THE COMPETITION-1998

TEAM UPDATE #1

Date: January 12, 1998

CORRECTIONS AND UPDATES TO THE MANUAL

Playing Field - Top View
Finals Rounds
Figure 1.2

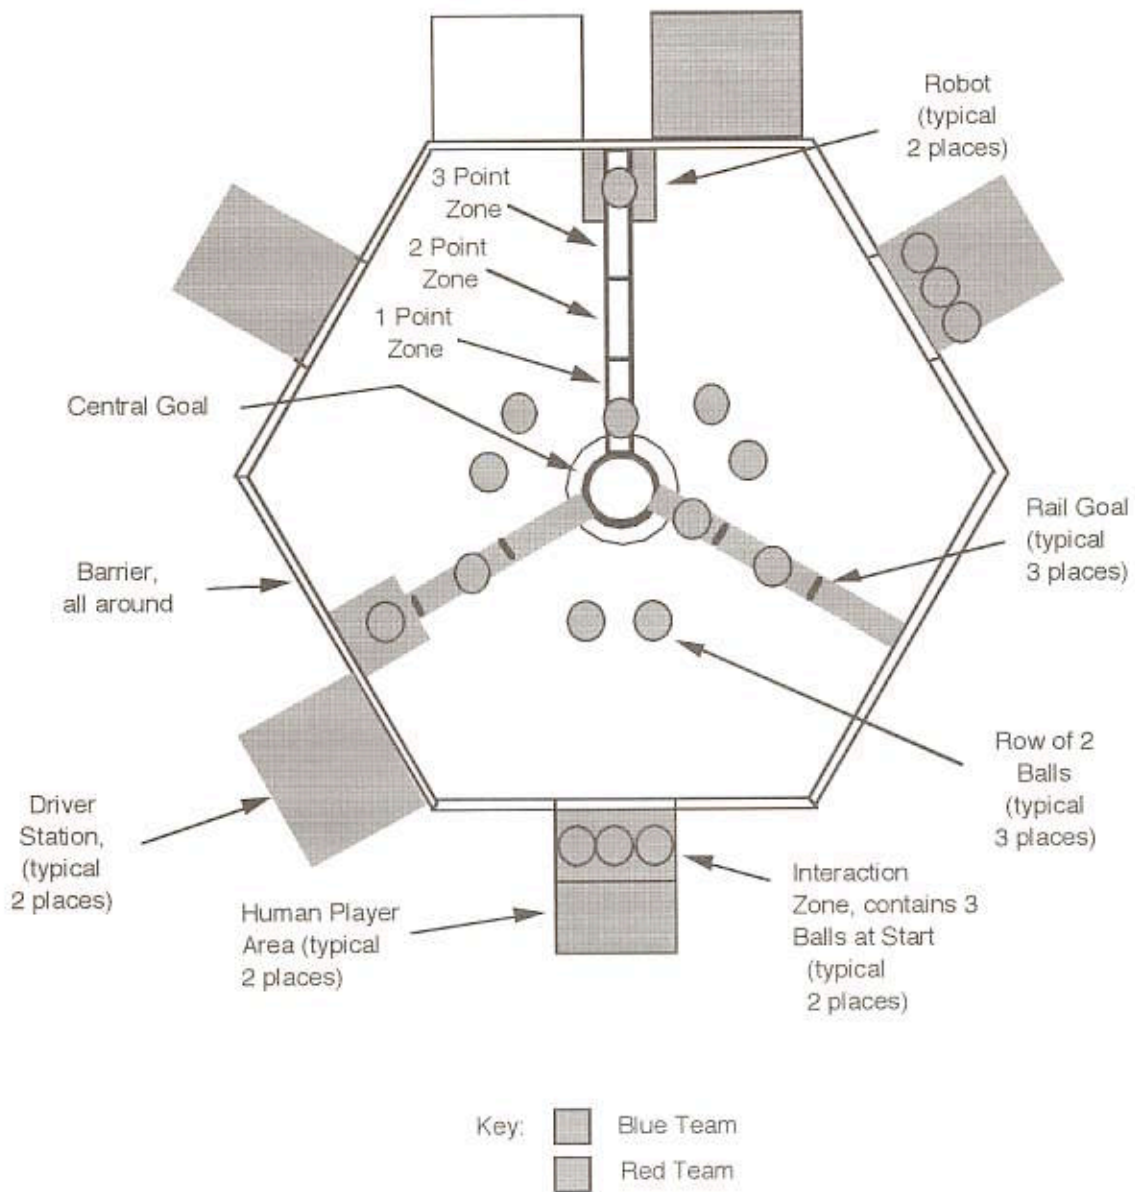
Figure 1.2 is updated as follows:

During the finals matches, only 6 balls will be on the playing field surface, as shown in Figure 1.2. Placement will be similar to double-elimination matches with respect to distance from the field border and the spacing between balls. However, each ball will be centered on a point located halfway between the center and outer points used for the corresponding three ball group during the double-elimination matches.

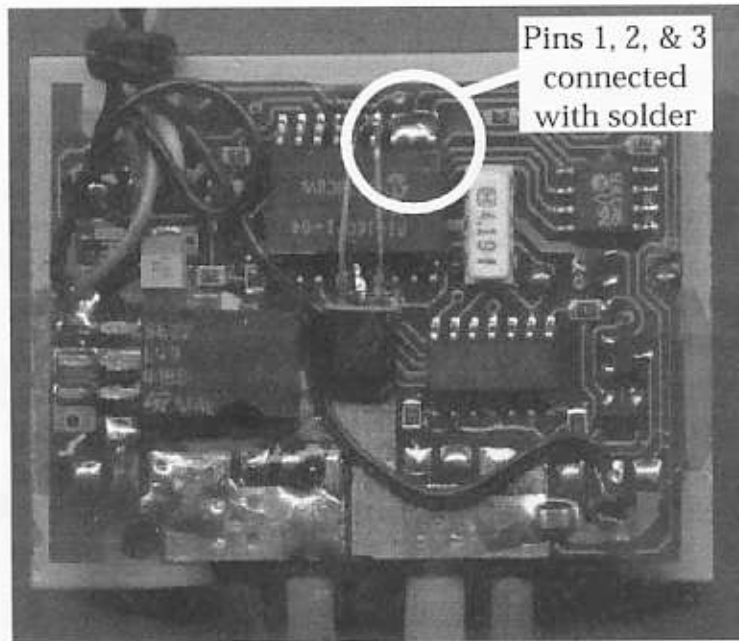
The proper solution to these problems is to use a lower gear ratio so that the drill motors operate at higher speeds and lower torques. This will not only lower the electrical current draw of the drill motors and prevent the above problems from occurring, it will also allow the motors to operate more efficiently and increase overall motor output power.

FIRST also recognizes that teams may not be able to change gear ratios before having to ship robots to event sites. Therefore, FIRST has decided to allow teams the option of modifying the speed controllers to bypass the current limiting circuit. Please note that performing this modification will void the warranty on the speed controllers and presents a number of risks.
